To: Susan Grant, Acting City Manager  
From: Alan Dodd, Director – Public Works  
Date: June 3, 2024  
Re: Change Order # 4 for Project #12765 PO 6189

Job Description: Project #12765, Prospect Lake Clean Water Center  
Contractor: Prospect Lake Water, L.P.  
Amount: Total amount of Change Order # 4 \$3,275,339 plus 0 additional days  
Funding: 10-494-7999-536-60-6599-P12765

Item No. 1 New Item #1 – Construction of 54-inch Feedstock Watermain and Project Company  
Administration Fees  
Adjust Contact Item – Lump Sum  
**ADDITION \$3,275,339**

This letter (“Scope Change Order Proposal Response”) is in response to Project Company’s Scope Change Order Proposal Request for the 54-inch Feedstock Water Delivery and Feedstock Water Connection at Project boundary TP-01 per Annex B-1(City Infrastructure Obligations) in the Comprehensive Agreement, sent to Kiewit on April 15<sup>th</sup>, 2024.

DRAWING #	SHT #
D-3	011
TOTAL:	12
CAD FILE:	12765-MULTI-DETL
DRAWING FILE NO.

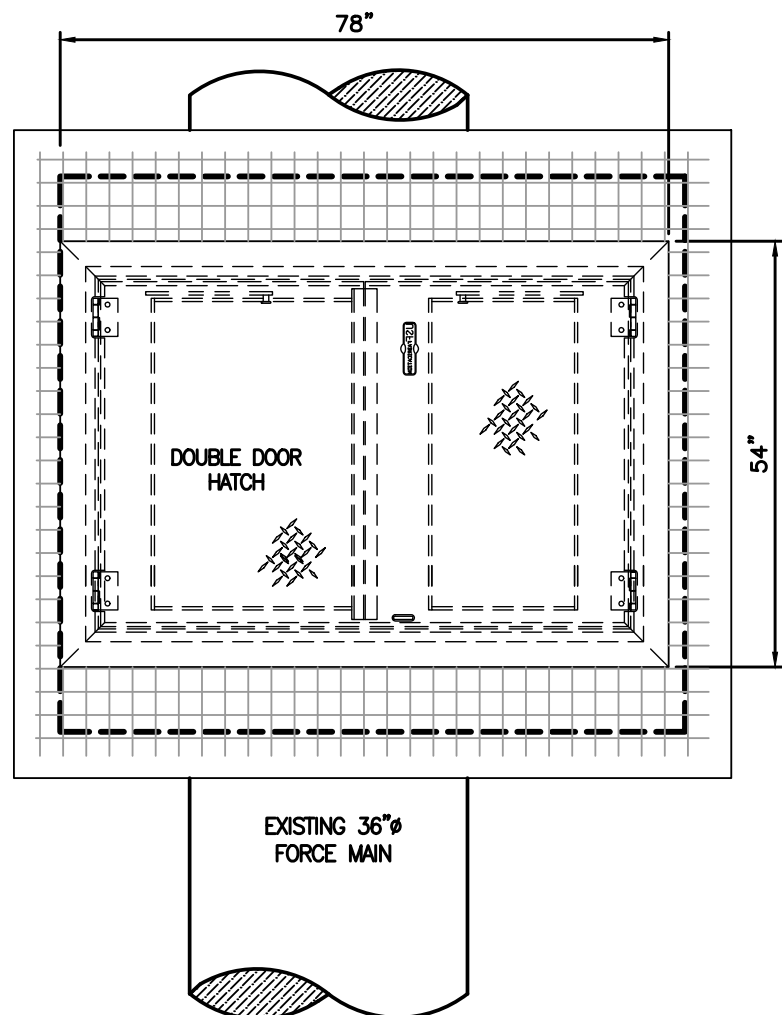
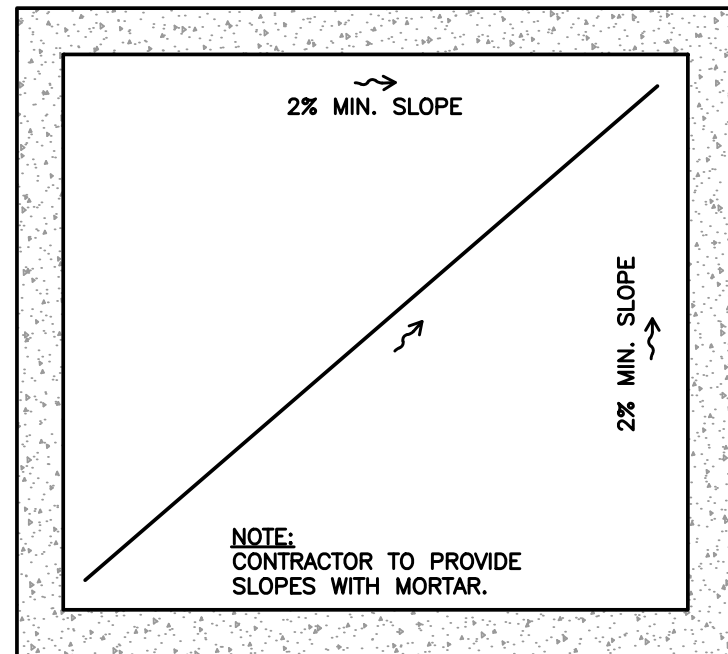
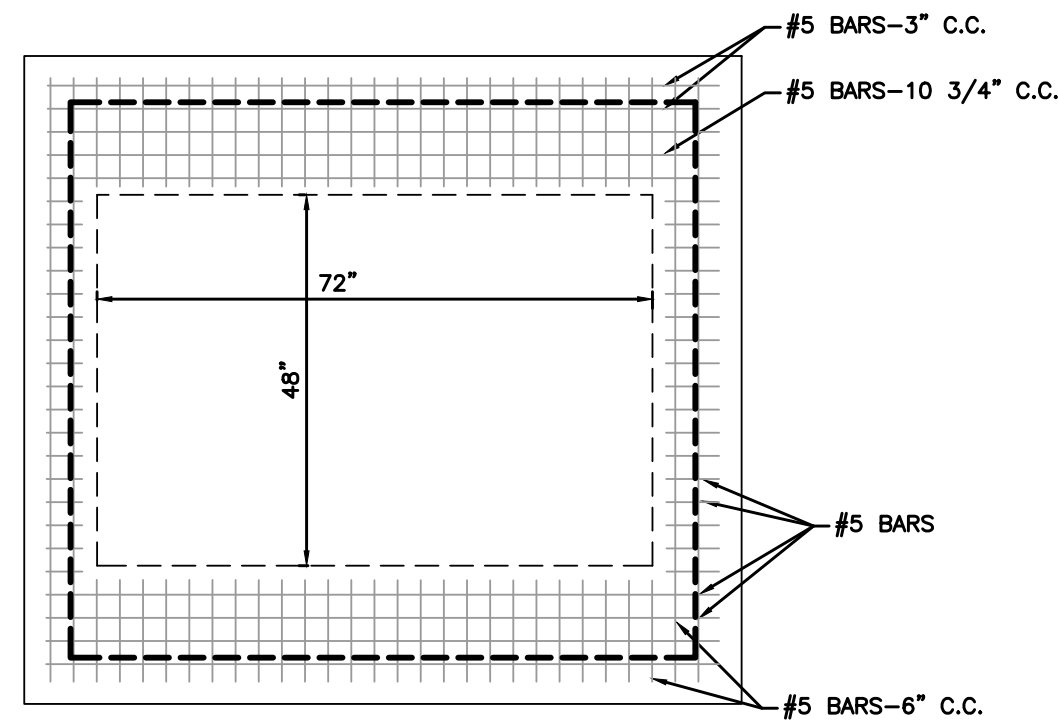
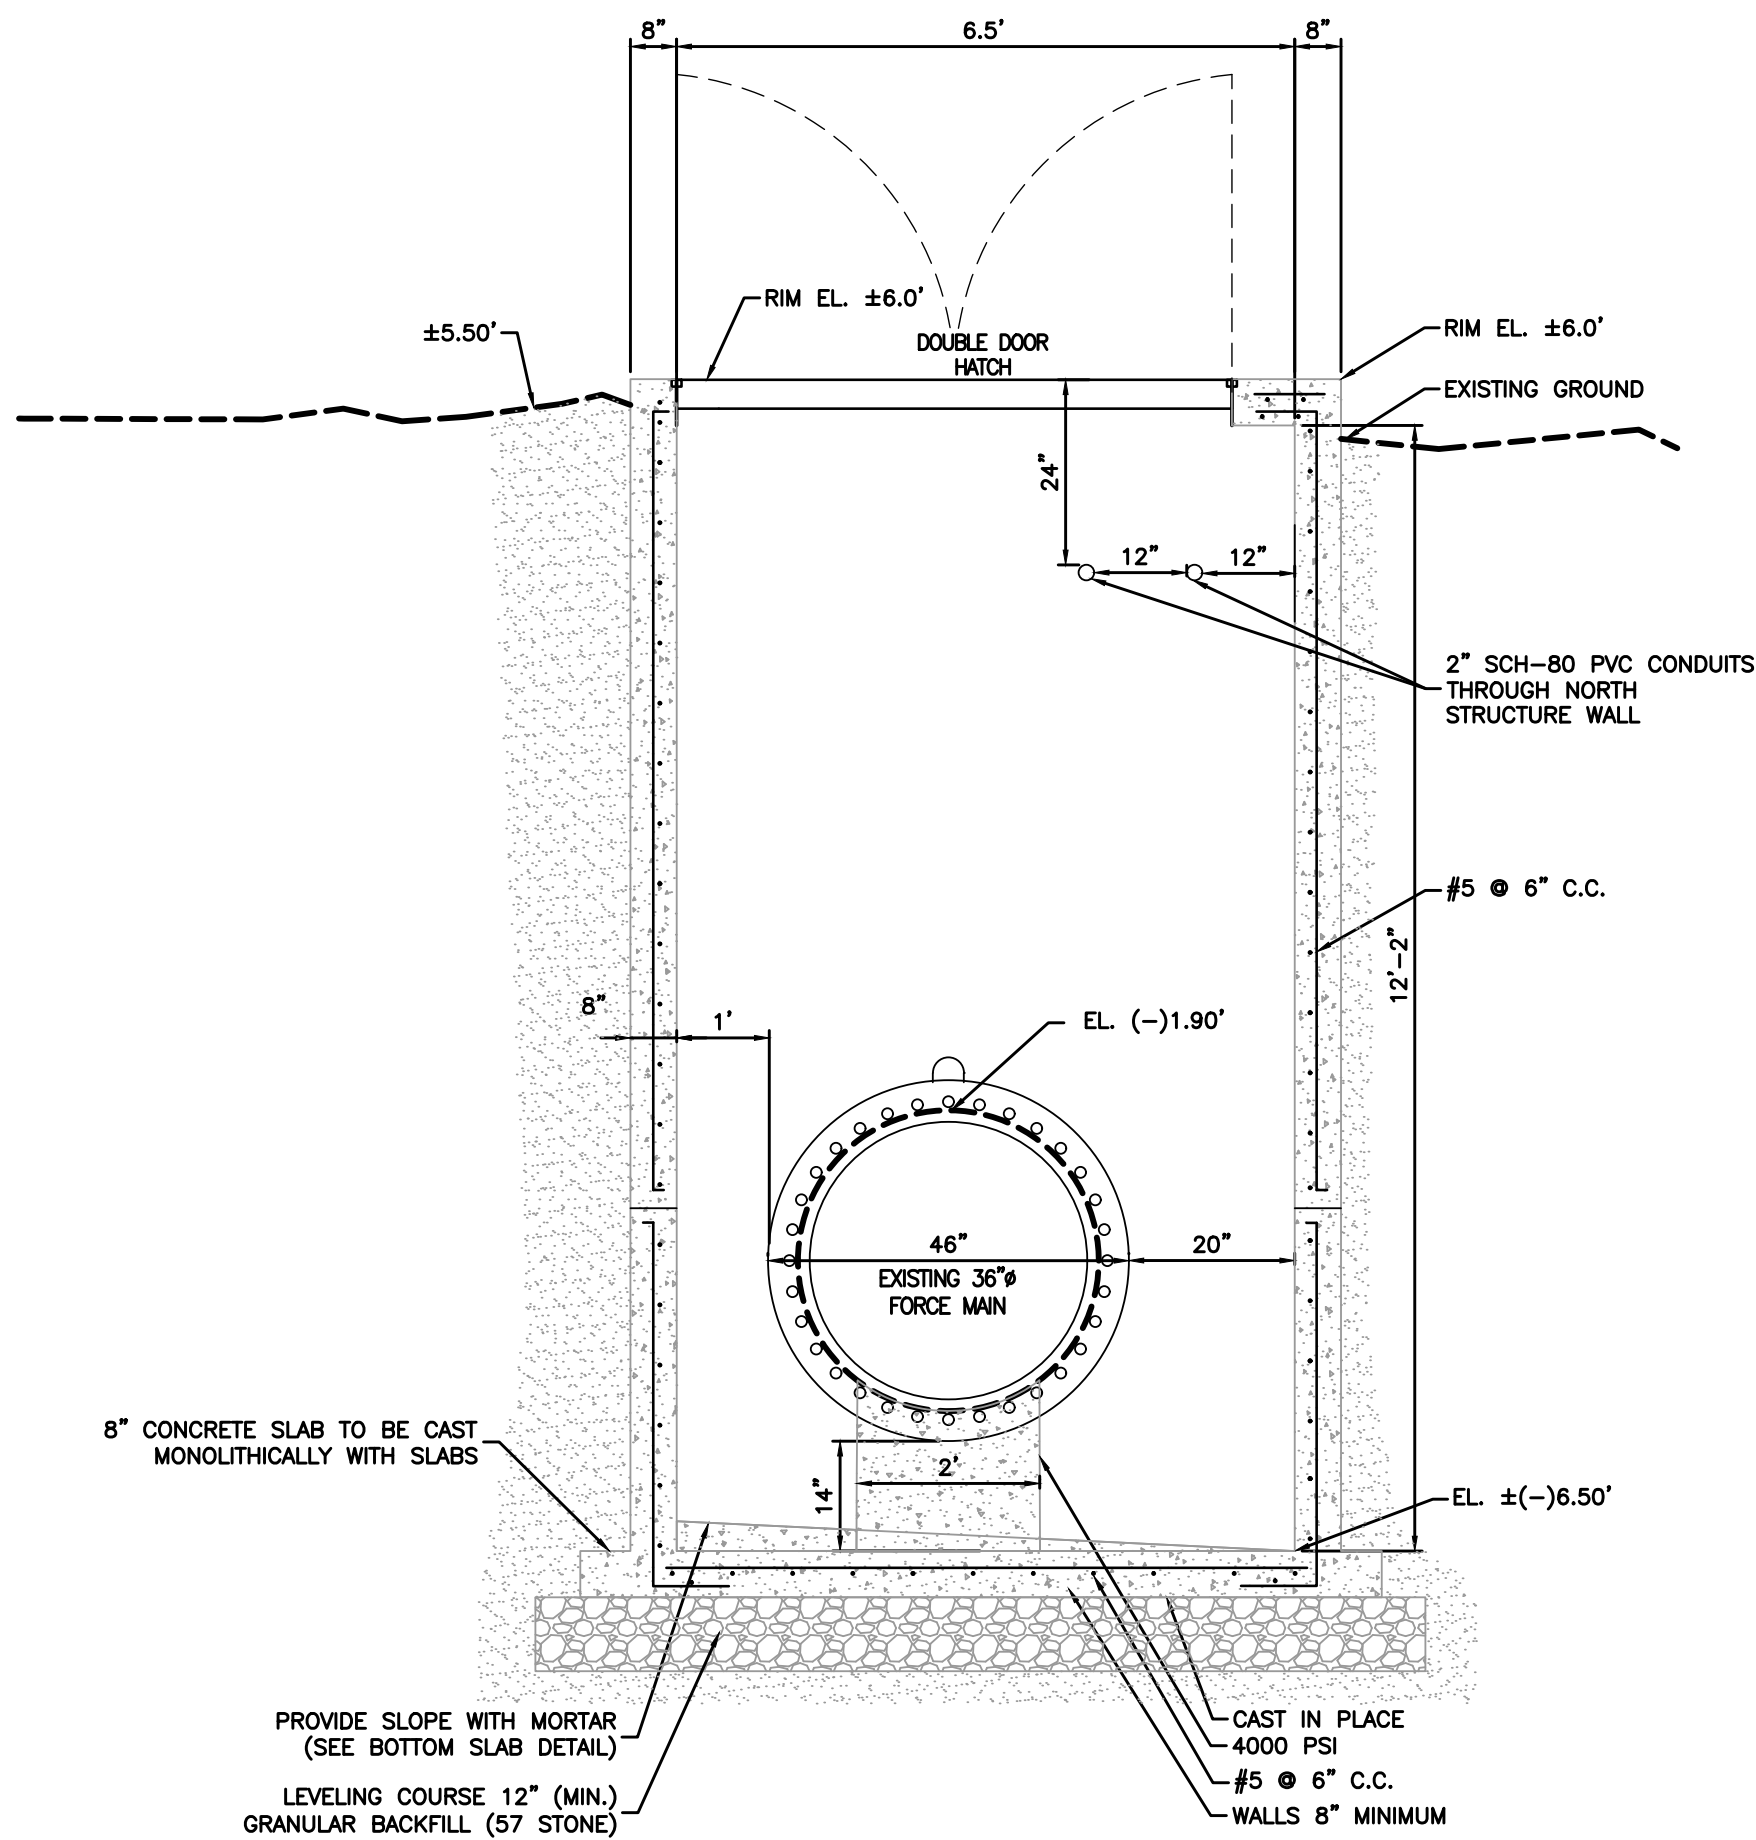
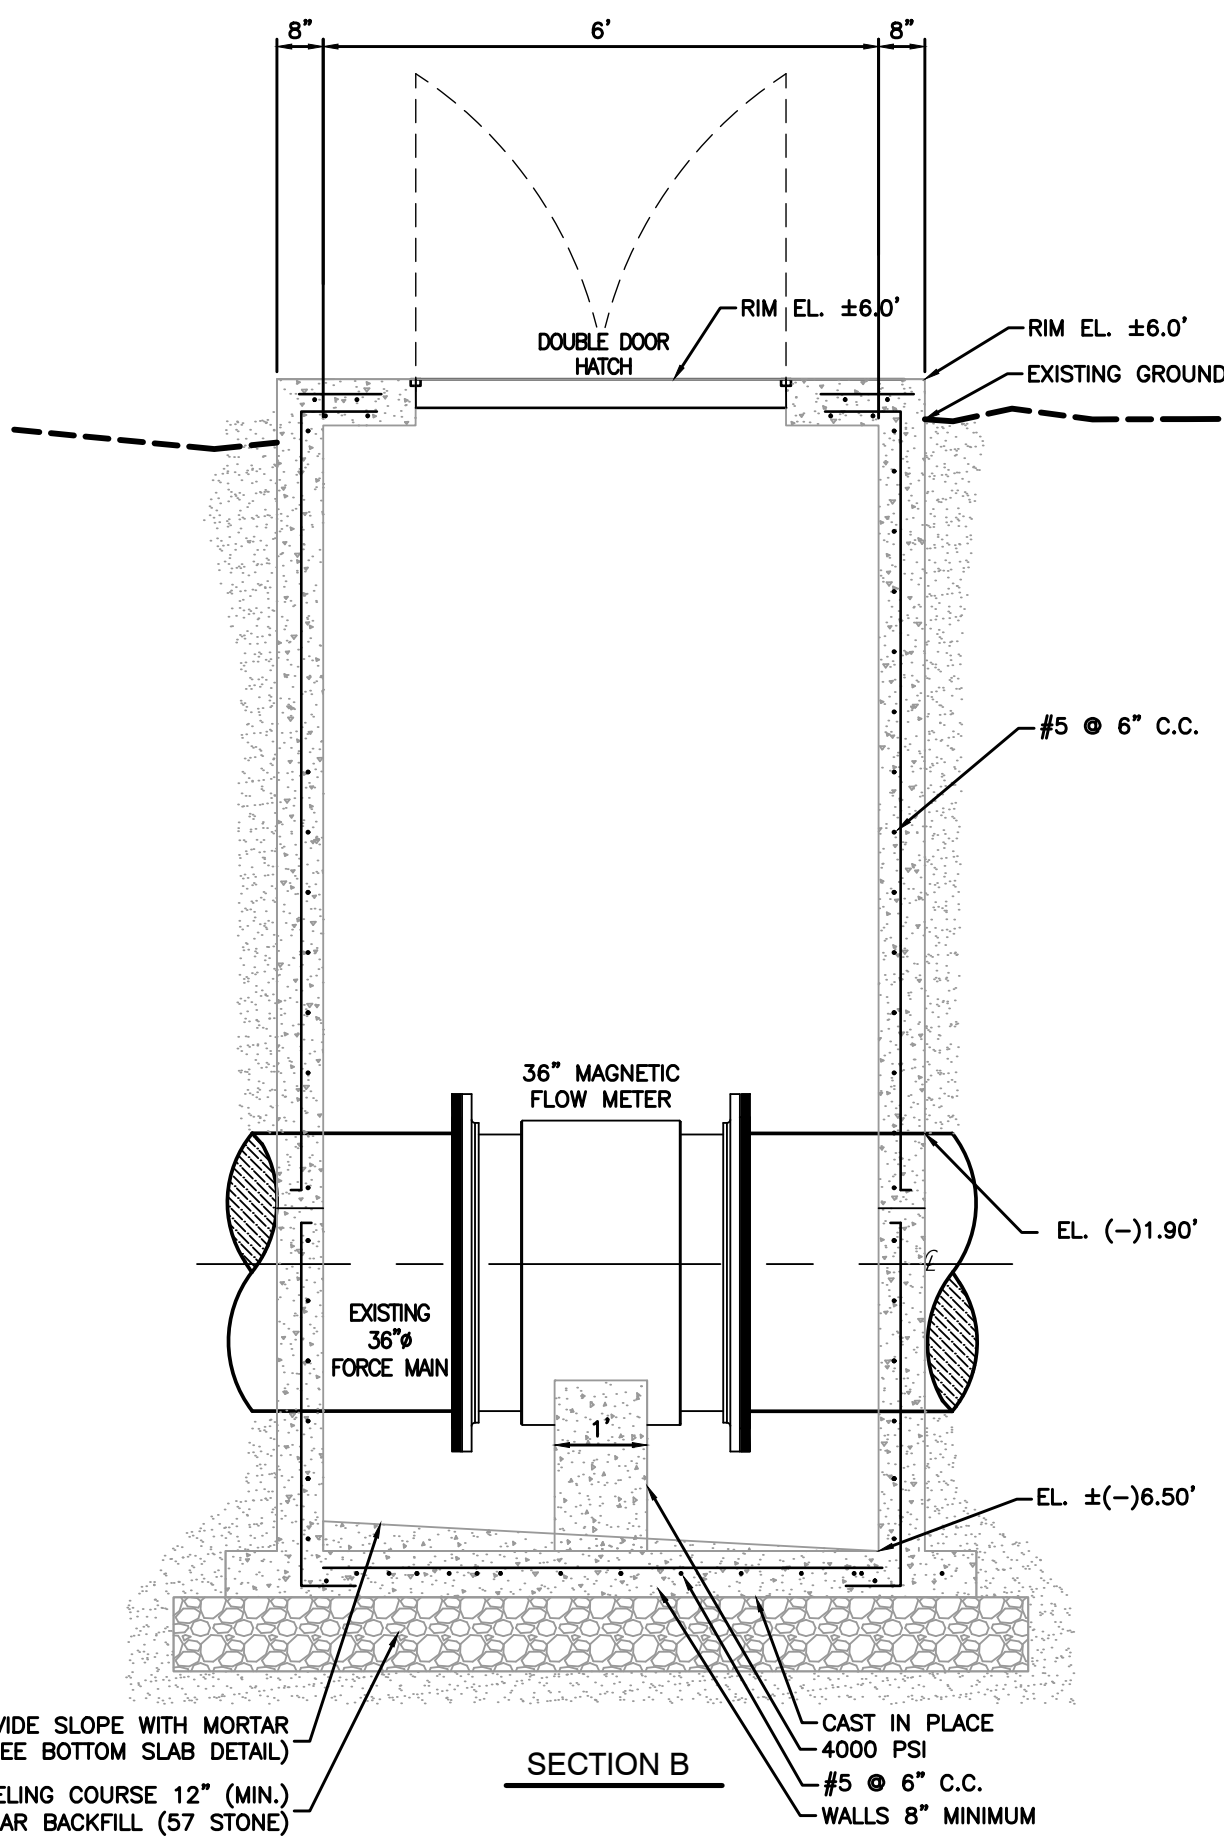
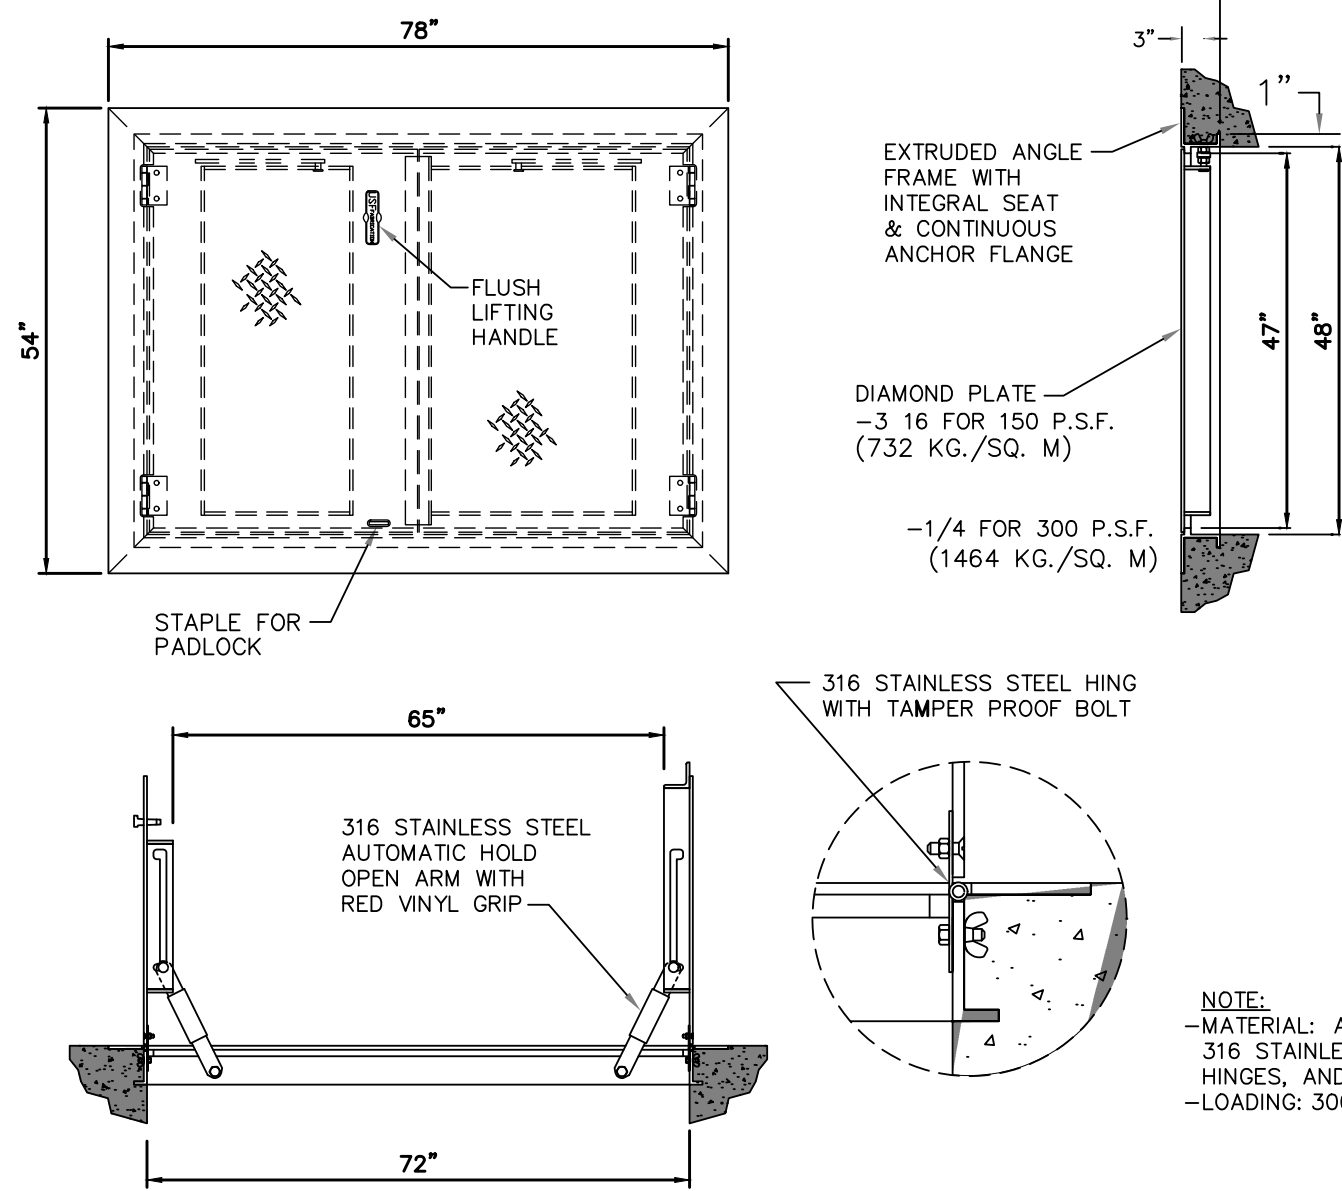
18. **Drawing D-3:** Drawing no. D-3 in the FWM Design Plan does not apply as there shall be no meter.
19. **Hazardous Materials:** General Note no. 44 in the FWM Design shall not apply. For the avoidance of doubt, Kiewit's rights and obligations with respect to hazardous materials will be as set out in the Comprehensive Agreement and the DB Contract.
